**Oil Leakage in the Area of the Upper Part of the Oil Pan and Crankcase: Checking Return Seal on Upper Part of Oil Pan and Replacing if Necessary (91/24)**

Vehicle Type: **718 Cayman GTS 4.0 (982) / 718 Boxster GTS 4.0 (982) / Boxster 25 years (982) / 718 Spyder (982) / 718 Cayman GT4 (982)**

Concerns: **Oil pan return seal**

*Oil leakage area*

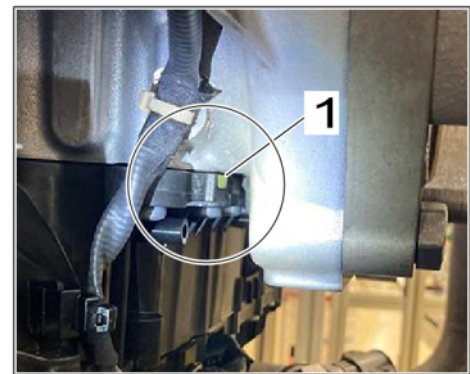
Cause: **Oil traces are detected on the oil pan on the side of the engine transmission flange.**

The leak is located in the area of the sealing point between the upper part of the engine oil pan and crankcase ⇒ *Oil leakage area -Circle-*, on green return seal ⇒ *Oil leakage area -1-* in the "window section" of the upper part of the oil pan.

Action: Check the return seal in the area of the "window section" and replace it with a **new component status** if applicable.

**Replacing the upper part of the oil pan, including the moulded seal, is not expedient** because this complaint involves a defect in the return seal in the area of the "window section" of the oil pan and not a defect in the oil pan itself.

*Affected seals*

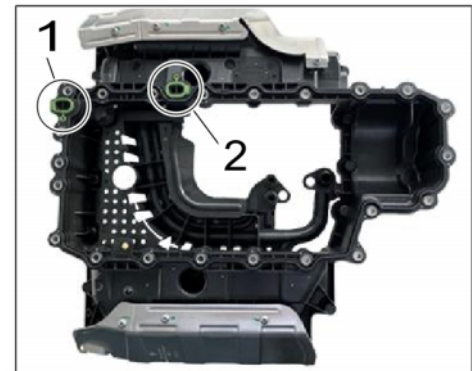
- 3 Replace previous return seals ⇒ *Affected seals -1 and 2-* on the upper part of the oil pan with **new, black return seals with a new component status**.  
 For procedure, see: ⇒ *Workshop Manual '175019 Removing and installing oil pan (upper part)'*

The previous component status of the return seal in green must no longer be used here.
